## II. REMARKS

### **Formal Matters**

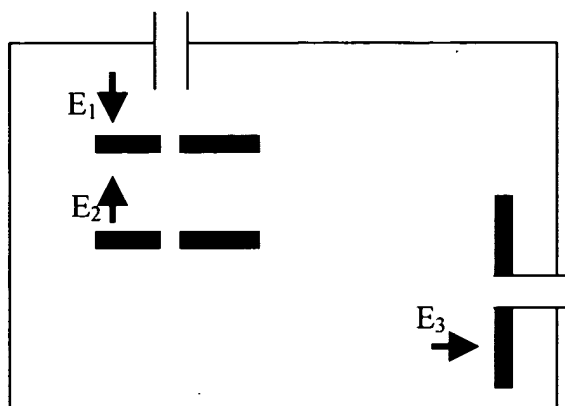
ionization chamber having, *inter alia*, three electric fields and means for generating a gaseous stream in a gas flow path extending from a first electrode to a second electrode. Solely for the Examiner's convenience and without any intention to limit the invention, an exemplary arrangement of electric fields is illustrated in the following figure (adapted from Fig. 2 of the instant application).

As the Examiner has correctly pointed out on page 6 of the Office Action, Park does not disclose an apparatus having three electric fields within the ionization chamber. Further, since the Park apparatus only discloses two electric fields, one of which surrounds the base of the sample inlet needle, ions exiting the sample inlet needle pass through only one electric field. As such, Park also fails to provide means for generating a gaseous stream in a gas flow path extending from a first electrode to a second electrode.

**FIG. 1**  
(PRIOR ART)

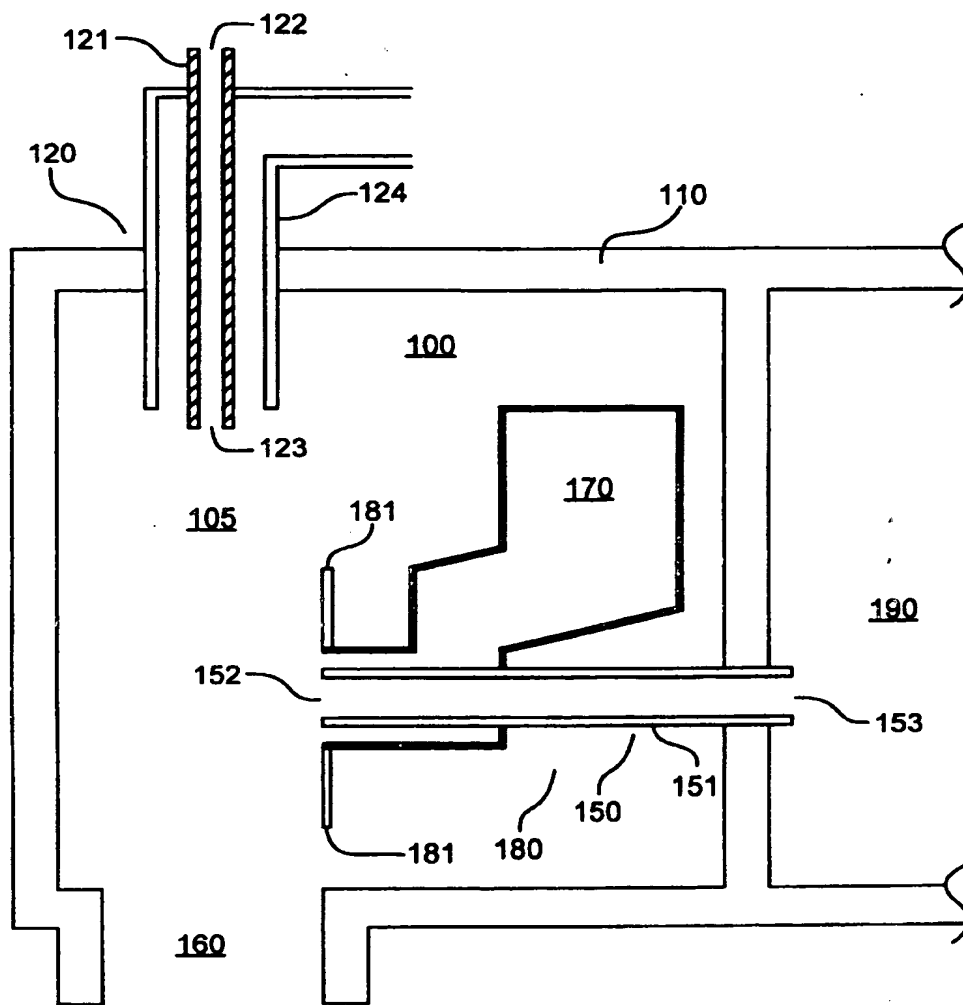
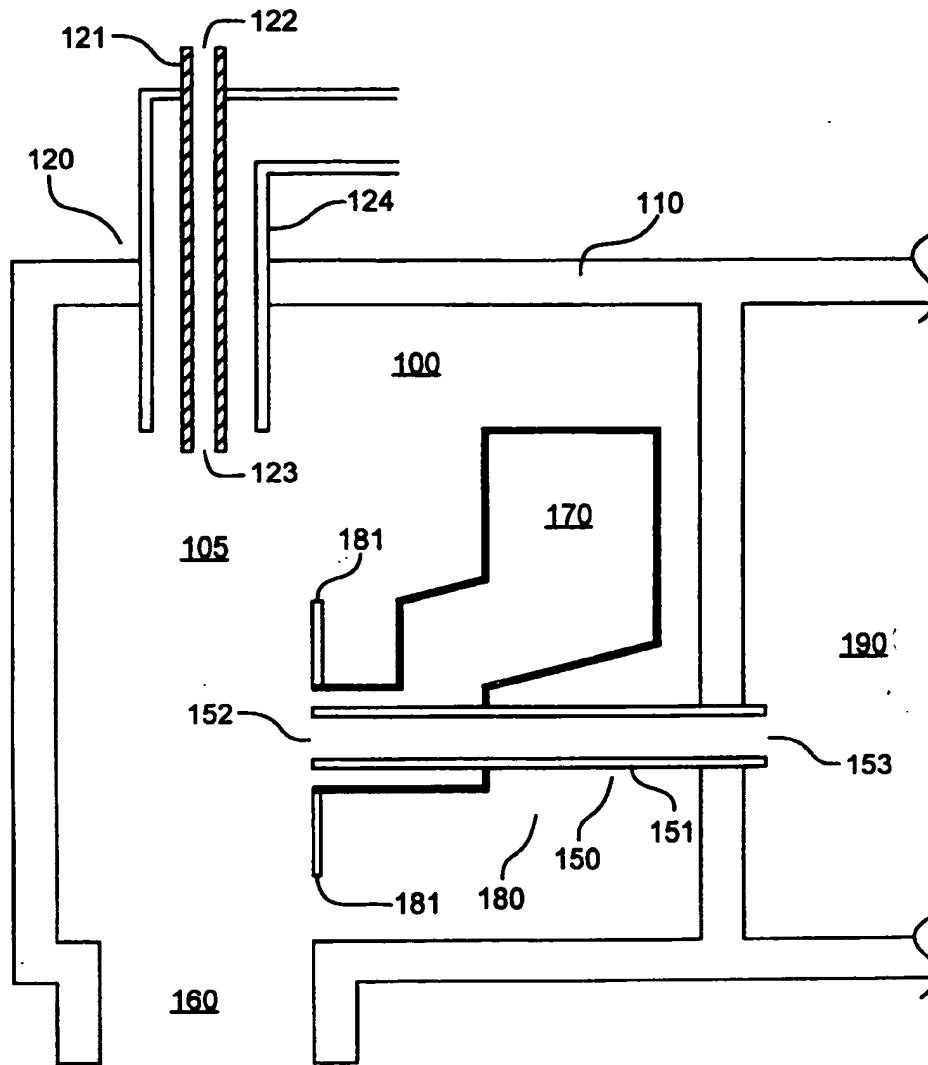
Figure 1 is amended to comply with MPEP § 608.02(g), indicating that the subject matter of Figure 1 is prior art.

Figure 1 was objected to as being incorrectly labeled. Applicants have amended the legend of Figure 1 to include the words "Prior-Art". This objection is believed to have been addressed by this amendment, and Applicants respectfully request withdrawal of this objection.

FIG. 2

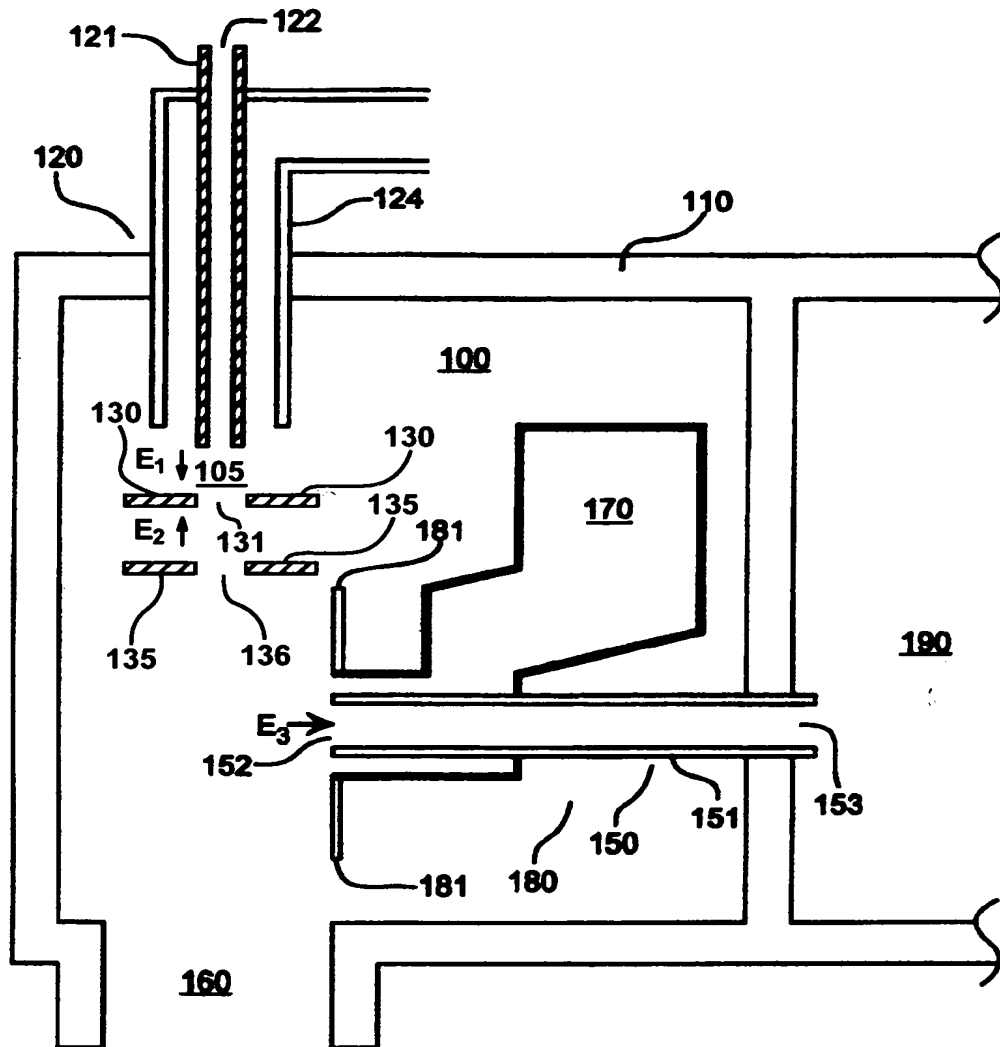
Substitute Figures 1-4 are filed with this response, with a "redline" marked up copy of each figure to show changes made. Support for the amendments to Figures 2-4 may be found on page 11 lines 25-32.

The drawings were objected to as failing to comply with 37 CFR § 1.84(p)(5), assertedly because a) the written description of the drawing recites the reference sign “154”, which is not shown in a drawing, and b) because the drawings show a reference sign “153” which is not described in the written description.

The specification has been amended to provide a description of element “154”.

Applicants respectfully submit that description of reference sign “153” may be found in line 25 on page 9 of the specification.

--As shown, a vacuum interface 180 is provided to allow communication between the ionization chamber 100 and the vacuum chamber 190. The vacuum interface 180 comprises a dielectric capillary 151 and an electrode ~~154~~ **181** and is similar to those used in conventional ionization chambers. The vacuum interface 180, and the electrode in particular, is electrically connected by direct physical contact with a wall of the apparatus separating the ionization chamber and the vacuum chamber. The interface may have any voltage as long as the interface voltage is more attractive to the ion than the voltage of the second electrode. Preferably, the interface voltage is at approximately ground potential. Because of the voltage difference between the second electrode and the vacuum interface, an ion emerging from the second electrode orifice will be repelled from the second electrode and attracted to the vacuum interface. As a result, the ion will travel
